SUBJECT: WATTS BAR NUCLEAR PLANT, UNIT 2 - STAFF ASSESSMENT OF INFORMATION PROVIDED PURSUANT TO TITLE 10 OF THE *CODE OF FEDERAL REGULATIONS*, SECTION 50.54(f), SEISMIC HAZARD REEVALUATIONS RELATING TO RECOMMENDATION 2.1 OF THE NEAR-TERM TASK FORCE REVIEW OF INSIGHTS FROM THE FUKUSHIMA DAI-ICHI ACCIDENT (TAC NO. MF3946)

STAFF ASSESSMENT BY THE OFFICE OF NUCLEAR REACTOR REGULATION

RELATED TO SEISMIC HAZARD AND SCREENING REPORT

WATTS BAR NUCLEAR PLANT, UNIT 2

Figure 3.3-1 Plot of Staff's and TVA's Base Case Shear-Wave Velocity Profiles for the Watts Bar, Unit 2 site

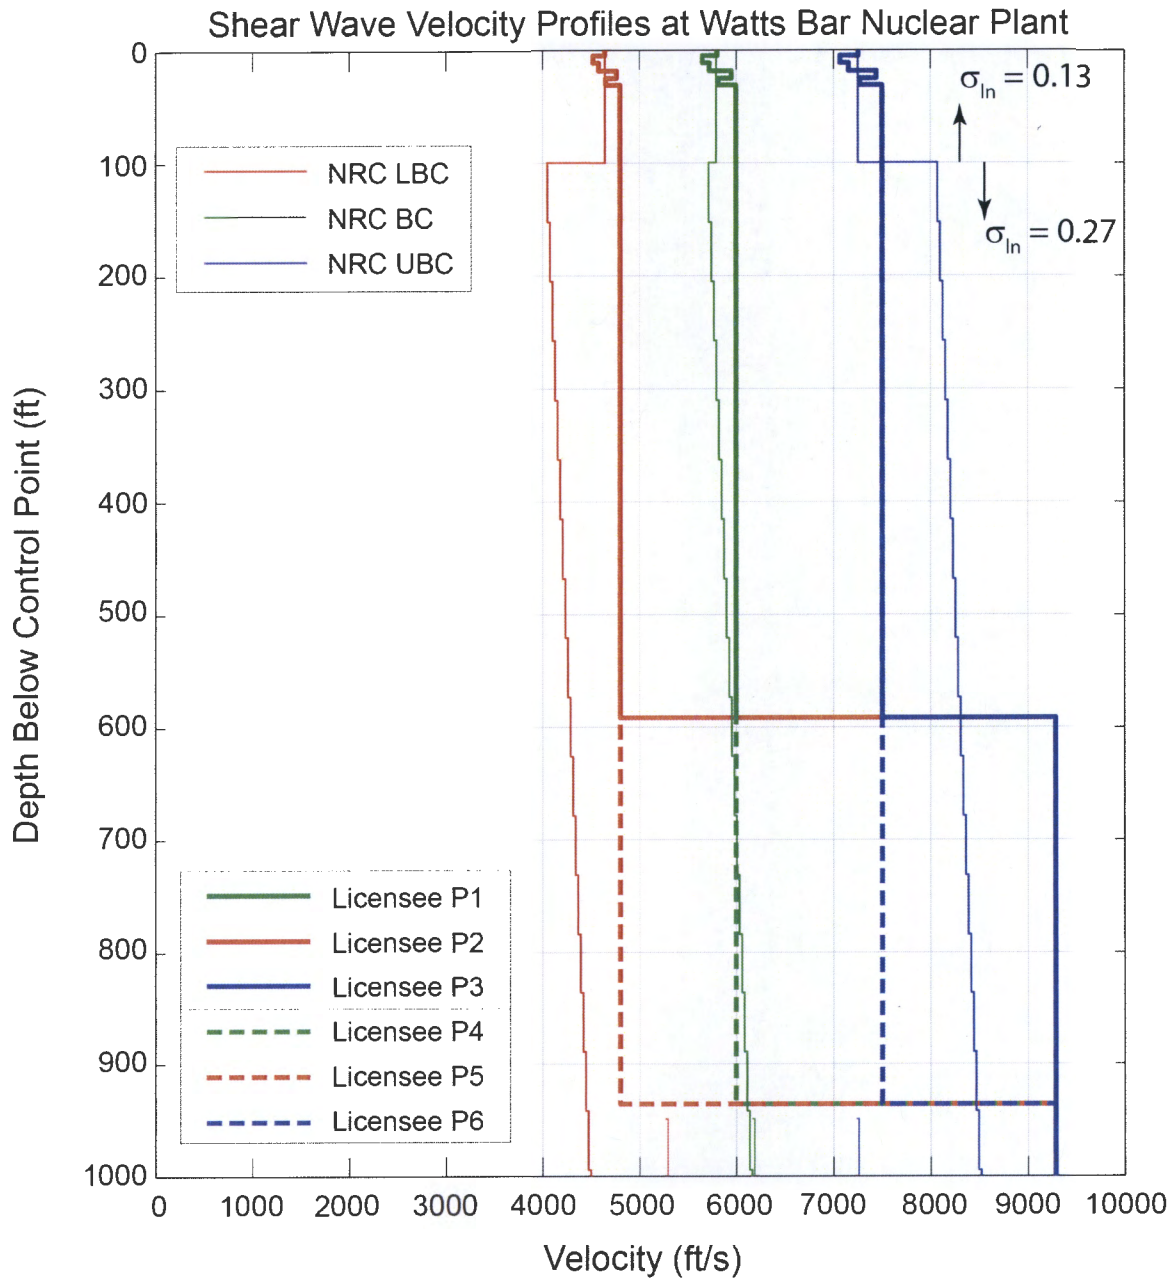
Figure 3.3-1 of this assessment shows the NRC staff velocity profiles compared to those developed by TVA. TVA developed two sets of three velocity profiles with varying depth-to-reference rock to account for the strata dip under the footprint of the plant, whereas the NRC staff used only one set of three profiles and placed the bedrock boundary at a depth of 1000 ft [305 m] below the control point. The near-surface (top 100 ft [31 m]) base-case velocity profiles are similar. However, below 100 ft [31 m] the spread in the NRC staff's velocity profiles is larger due to implementation of a larger epistemic uncertainty. In addition, the NRC staff's velocity profiles increase linearly with depth following the SPID guidance, whereas, TVA used a constant velocity with depth.

Figure 3.3- 2 Plot Comparing the Staff's and TVA's Median Amplification Functions and Uncertainties for the Watts Bar, Unit 2 site

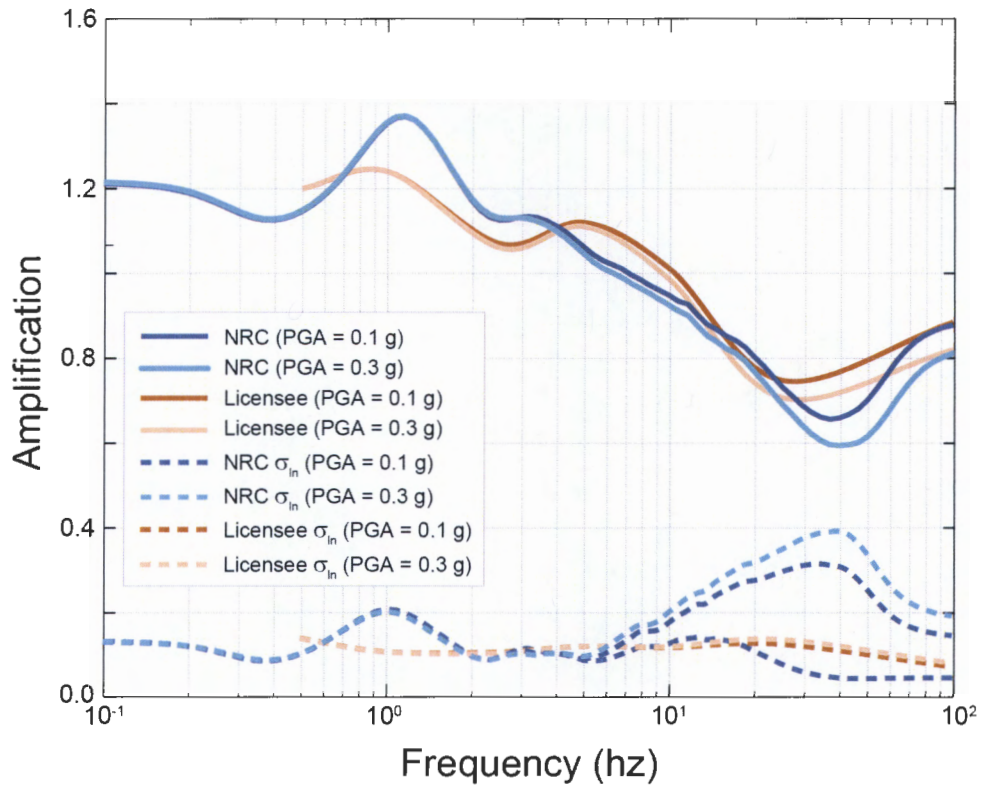
Figure 3.3-2 of this assessment shows a comparison of the NRC staff's and TVA's median site amplification functions and uncertainties for two of the eleven input loading levels. As shown in this figure, TVA's amplification functions are slightly lower below 4 Hz, and, on average, slightly higher above 4 Hz. The differences in the amplification function at lower frequencies (~ 1Hz) could be due to TVA using an additional set of three velocity profiles P1, P2, and P3, which has broadened the peak response. However, the NRC staff finds that these small differences are acceptable for this application because they are within the limits of the uncertainties.

Figure 3.4-1 Comparison of the Staff's GMRS, TVA's GMRS, and the SSE for the Watts Bar, Unit 2 site

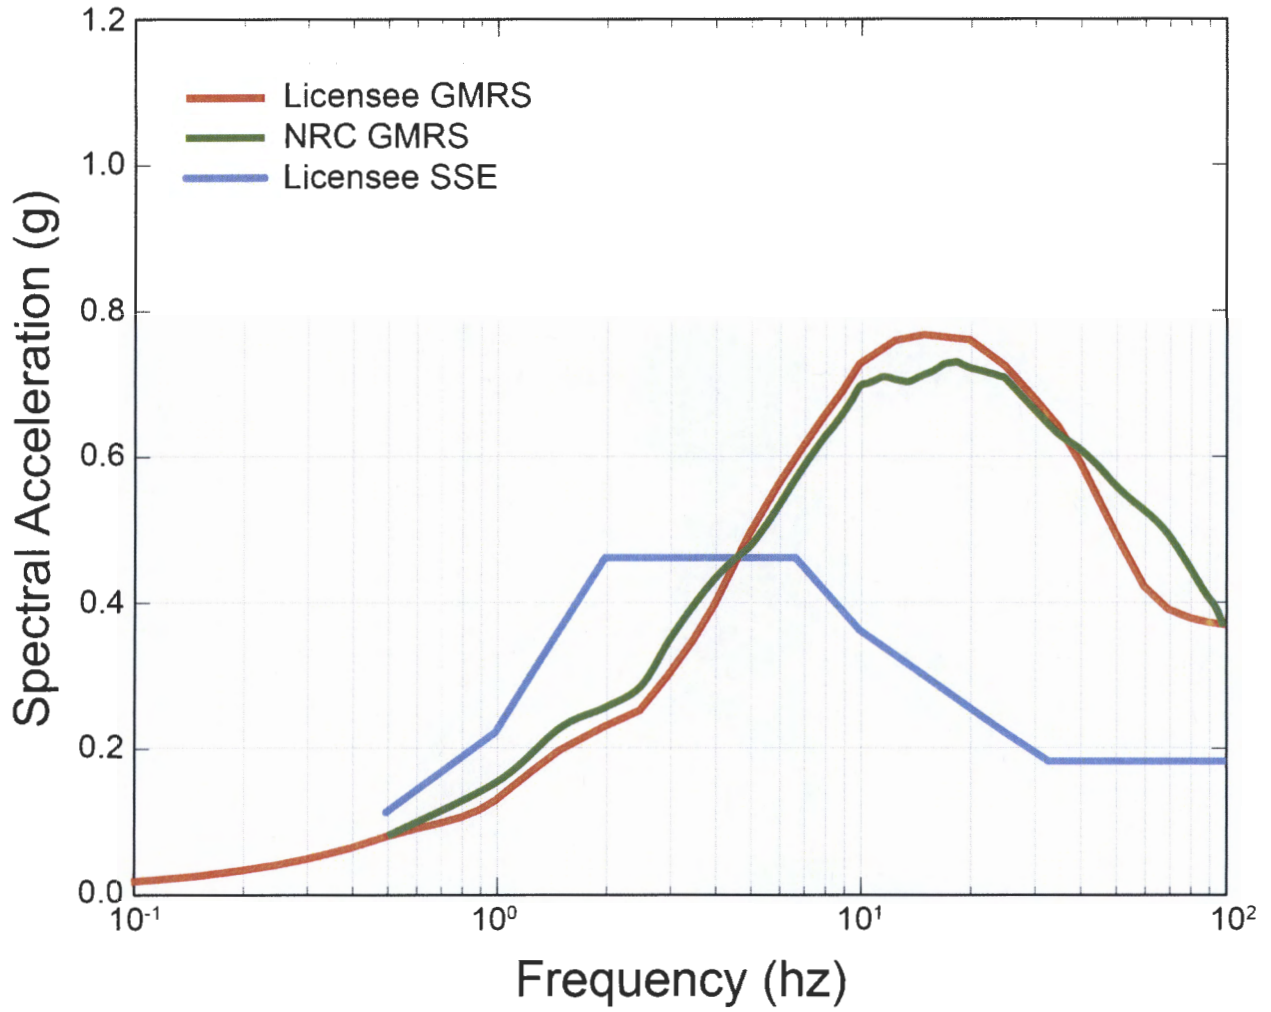
The NRC staff independently calculated the 10^{-4} and 10^{-5} UHRS using the results of its confirmatory PSHA and site response analyses, as described in Sections 3.2 and 3.3 of this assessment, respectively. Figure 3.4-1 of this assessment shows a comparison of the GMRS determined by TVA to that determined by the NRC staff.

As shown in Figure 3.4-1 of this assessment, TVA's GMRS shape is generally similar to that calculated by the NRC staff at frequencies less than 10 Hz. However, the NRC staff's confirmatory GMRS is somewhat lower than TVA's at 10-40 Hz, and slightly higher above 40 Hz. As described in Section 3.3 of this assessment, the NRC staff concludes that these minor differences over the higher frequency range are primarily due to the differences in the site response analyses performed by TVA and NRC staff. The NRC staff concludes that these differences are acceptable for the response to the 50.54(f) letter because TVA followed the guidance provided in the SPID with respect to both the PSHA and site response analysis for the Watts Bar, Unit 2 site.

The NRC staff confirmed that TVA used the present-day guidance and methodology outlined in RG 1.208 and the SPID to calculate the horizontal GMRS, as requested in the 50.54(f) letter. The NRC staff performed both a PSHA and site response confirmatory analysis and achieved results consistent with TVA's horizontal GMRS. As such, the NRC staff concludes that the GMRS determined by TVA adequately characterizes the reevaluated hazard for the Watts Bar, Unit 2 site. Therefore, this GMRS is suitable for use in subsequent evaluations and confirmations, as needed, for the response to the 50.54(f) letter.
